# **Intel<sup>®</sup> 82599 10 GbE Controller**

**Specification Update**

Revision 3.7  
331521-006

**Figure 1-1 Example with Identifying Marks**

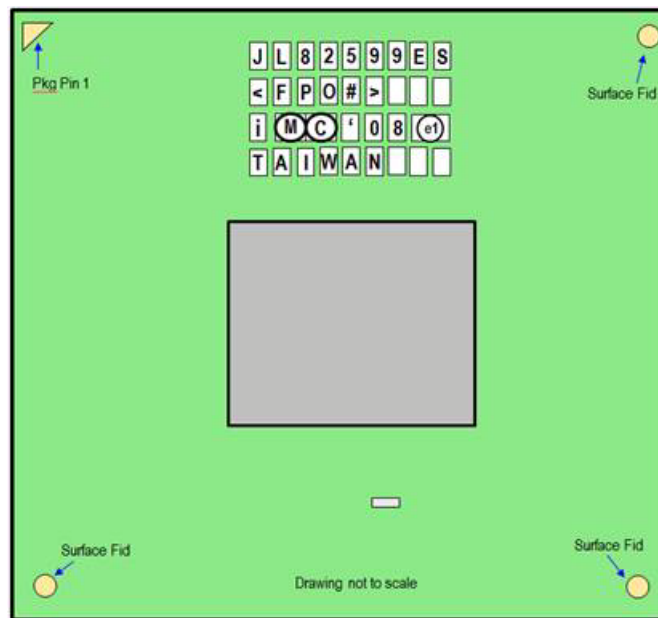
3.1	March 27, 2014	<b>Miscellaneous Updates:</b> <ul style="list-style-type: none"><li>Marking Diagram in Figure 1-1 updated to reflect new substrate.</li></ul>

Intel incorporates an internal designator of a dash mark (–) that is visible on the die side of the package, and is approximately 300 x 1000 nm in size. The actual location may differ from the example pictured. This mark is intended for internal purposes only and does not affect the product performance as designed. The customer's visual inspection system should be updated to allow for this feature.
